C4-0

OVERALL GRADING PLAN

5		
4		
3		
2		
1	08/01/2023	PER TOWN OF ROLESVILLE COMMENT
REV	06/01/2023	INITIAL SUBMITTAL

G:\NCA\Projects\Lennar\8430-03 - Lennar - School Street - Rolesville\03 - DWG\PlanSheets\On-Site\C4-0 - GRAD-PLAN.dwg ENLARGED GRADING PLAN (6 OF 6) Plotted: 8/1/2023 2:28:47 PM

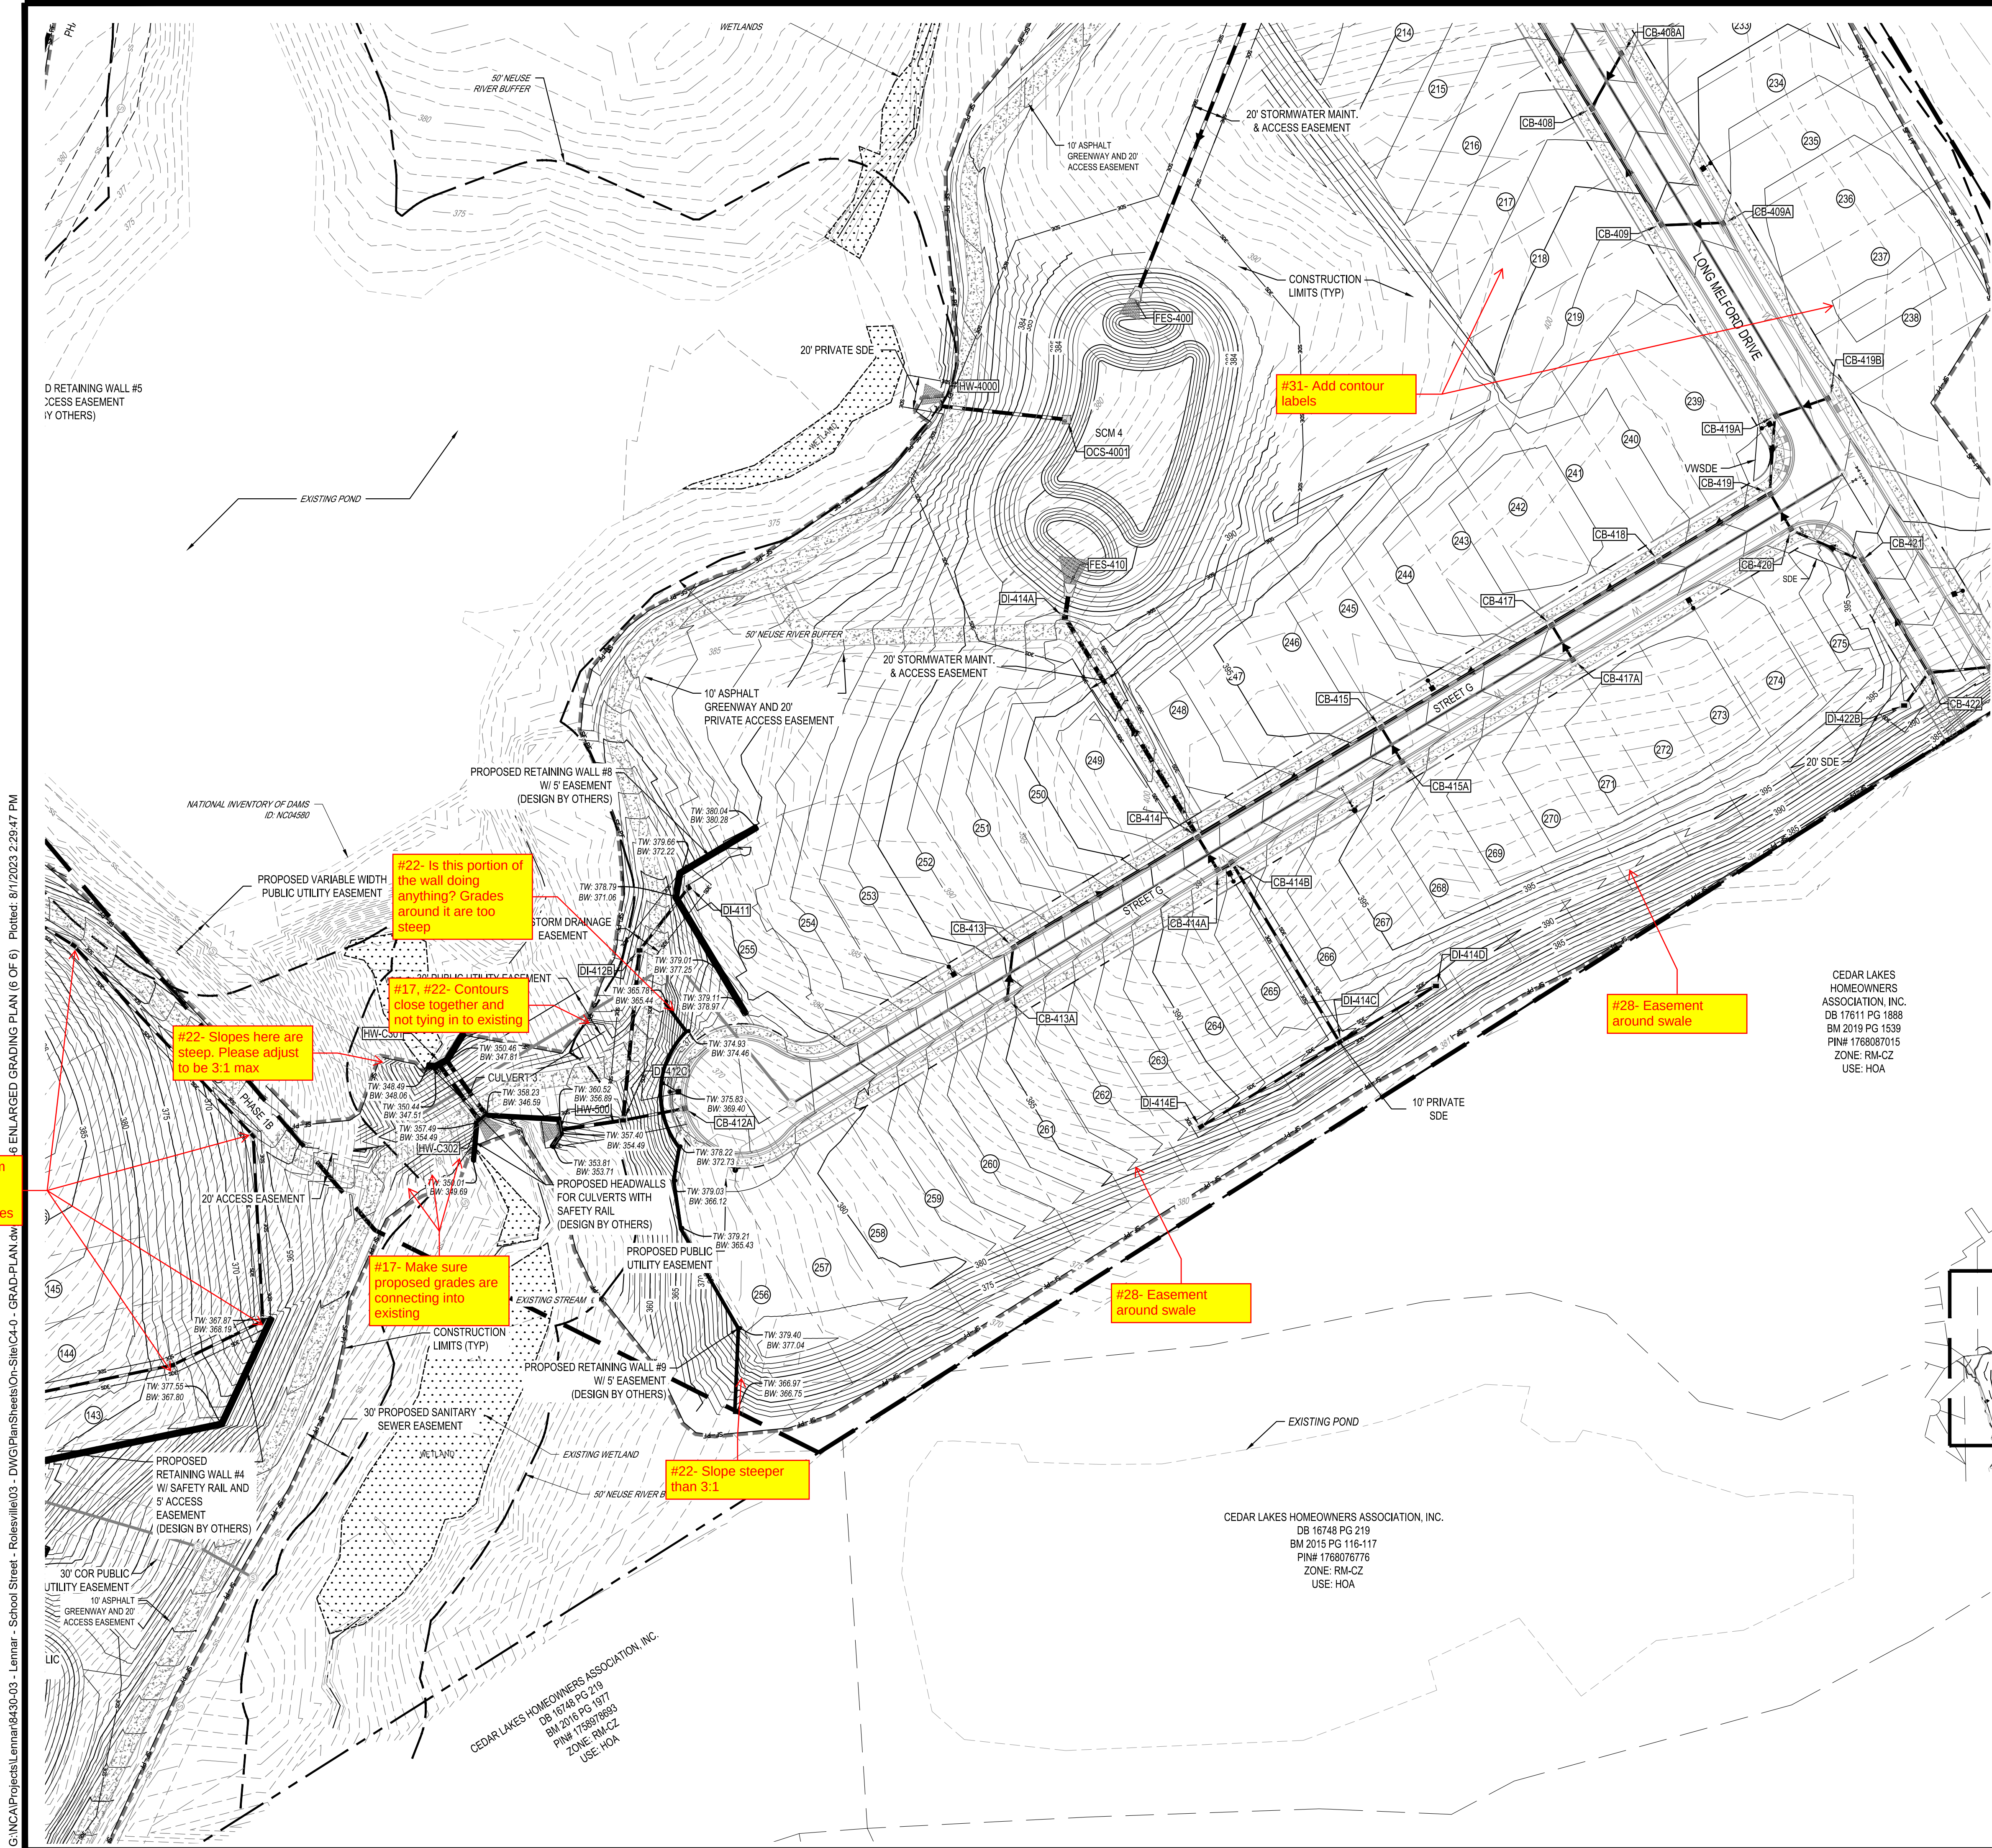
#20- Label all storm structures and ensure they are included in storm tables.

#22- Grades steep in this section

#35- Fix contours in this area

#34- If this is truly a low point, there should be a storm inlet for collection. If it is not a low point, adjust label text and/or location to reflect this

#20- Label all storm structures and ensure they are included in storm tables.

#20- Label all storm structures and ensure they are included in storm tables.

#31- Label additional contours in this area

#37- Wall is in greenway easement.
#22- Grades going up to wall are too steep, consider extending wall or looking into some other solution.

#19- Repeat comment: Consider the angle of the pipes and direction of flow for the storm sewer system.

#16- Provide more separation between storm inlet and sanitary manhole

#36- Adjust contours in this area

#20- Label structure and ensure it's included on storm tables

#36- Adjust and label contours in this area

#4- Leader not pointing at retaining wall, please adjust or remove.

#20- Include pipe and structure information

#20- Label all storm structures and ensure they are included in the tables

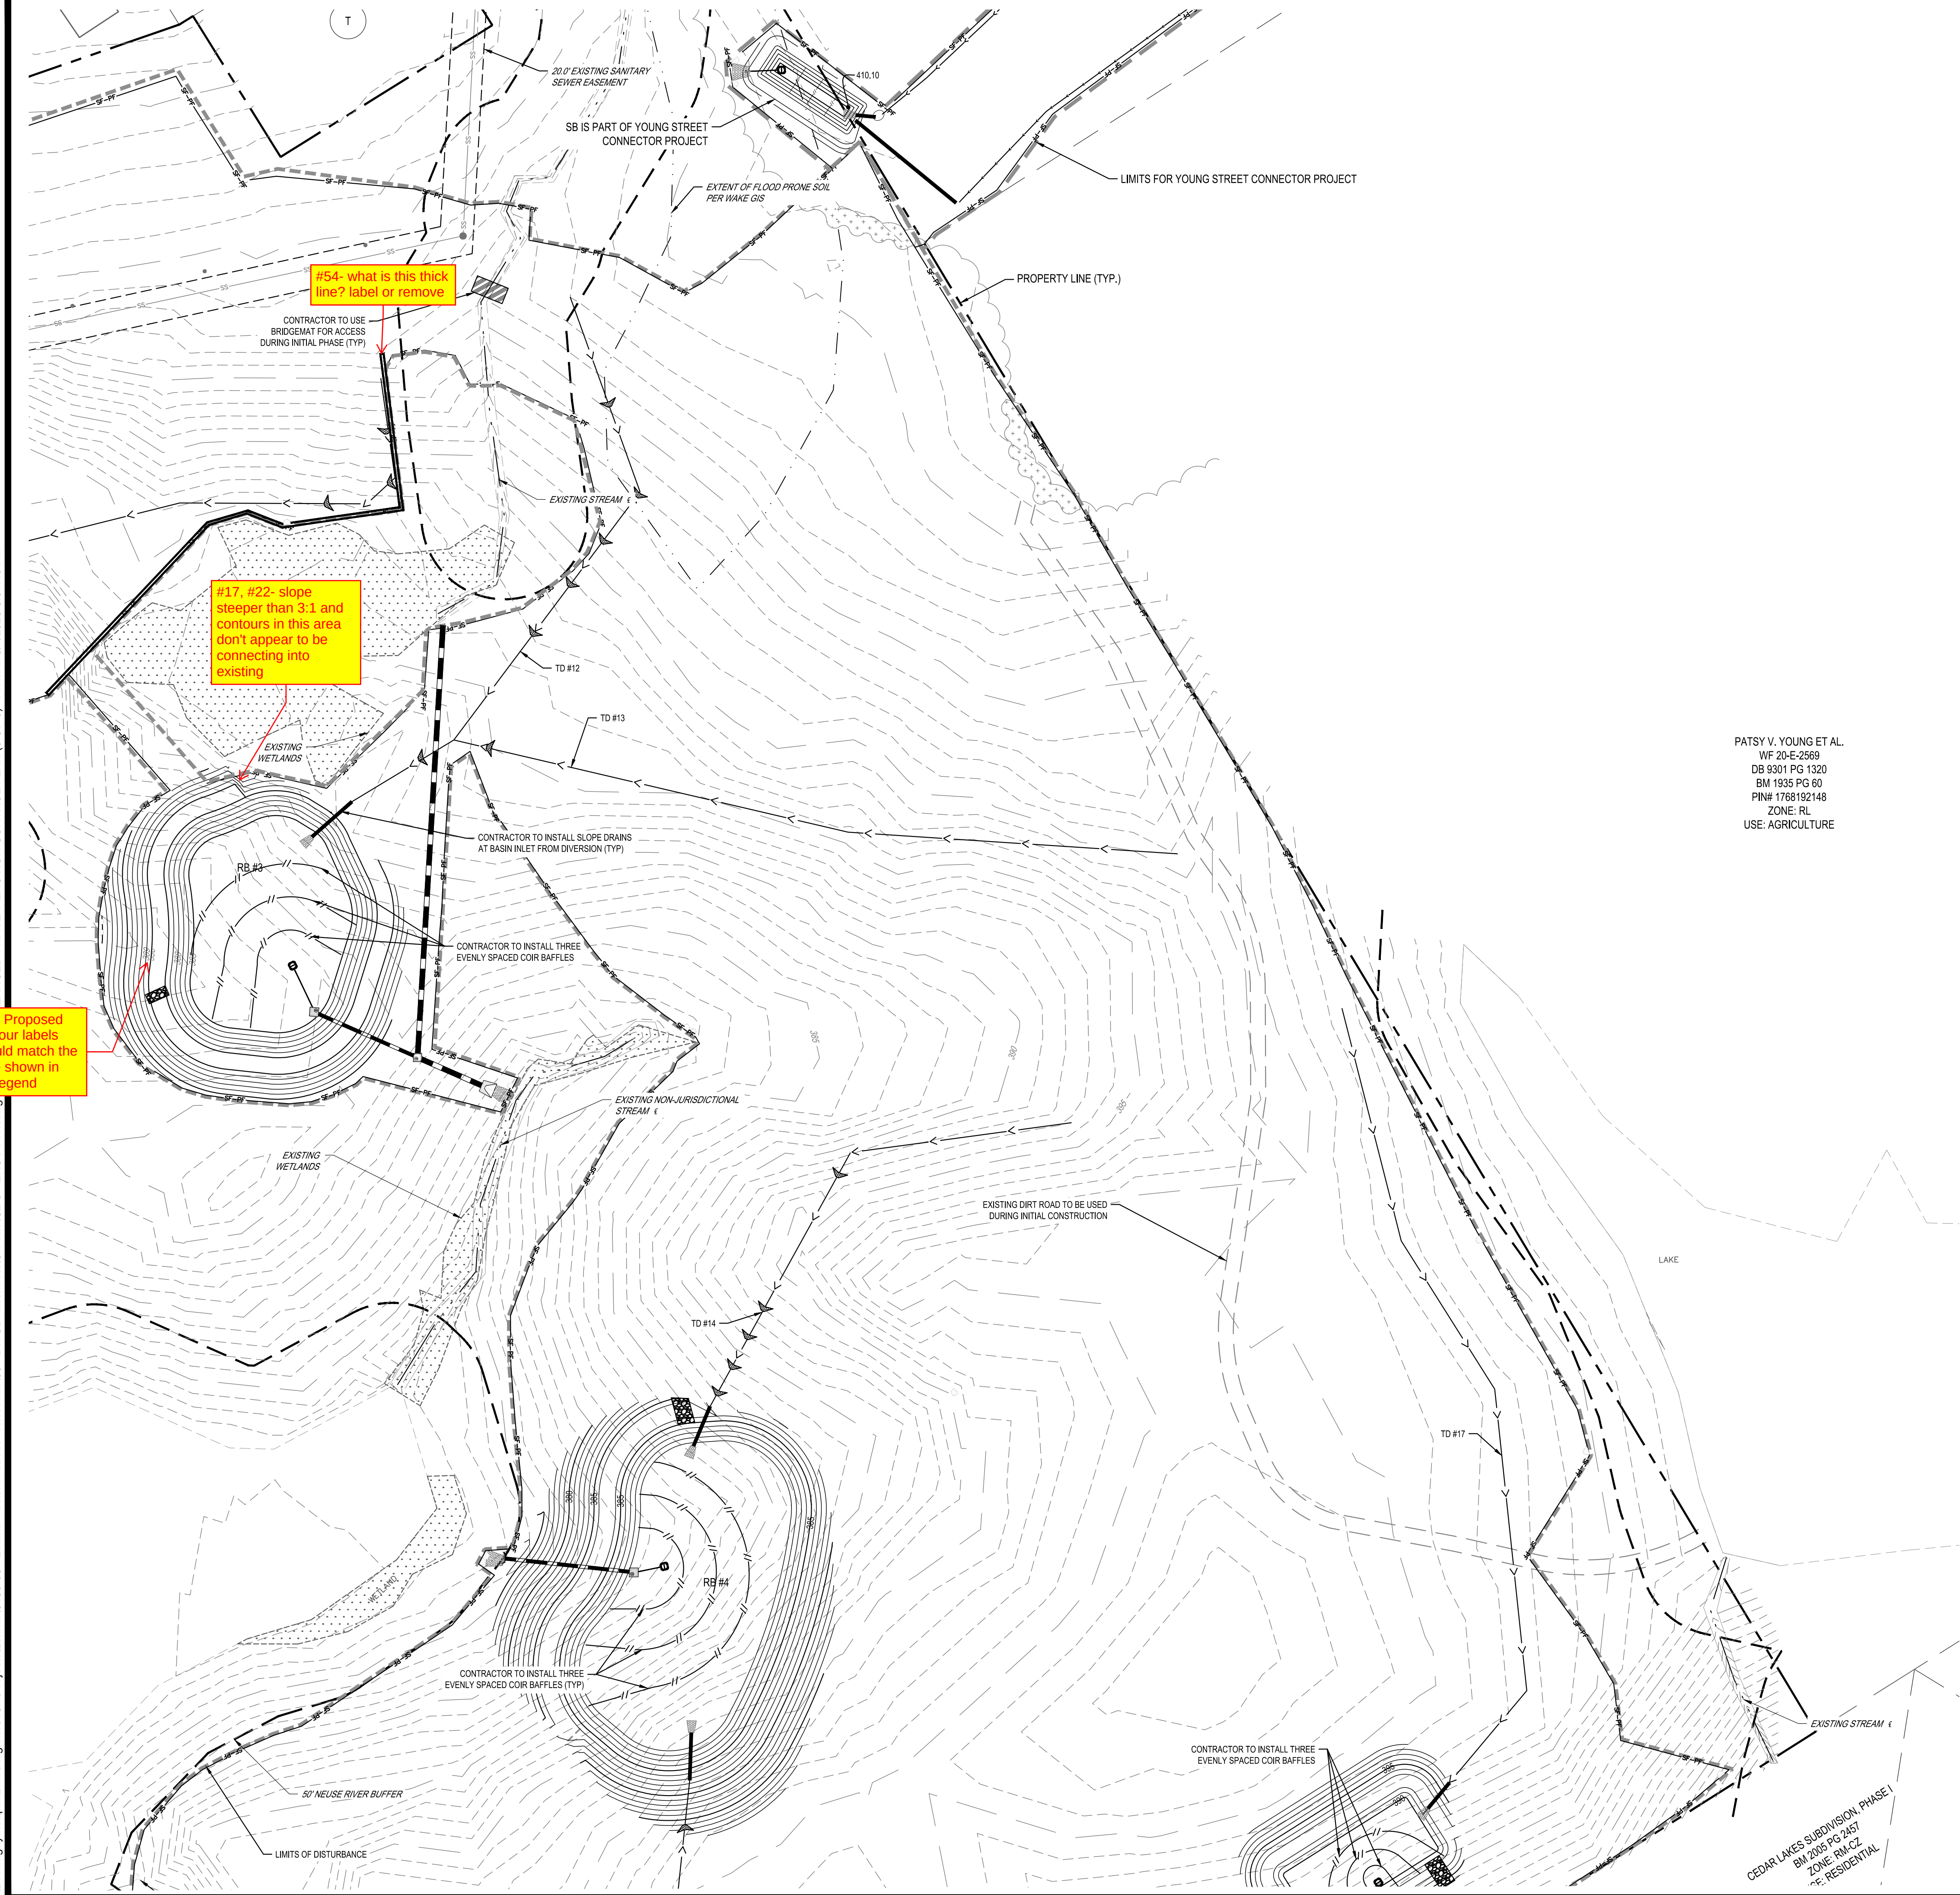
#50- Proposed contour labels should match the style shown in the legend

#17, #22- slope steeper than 3:1 and contours in this area don't appear to be connecting into existing

#54- what is this thick line? label or remove
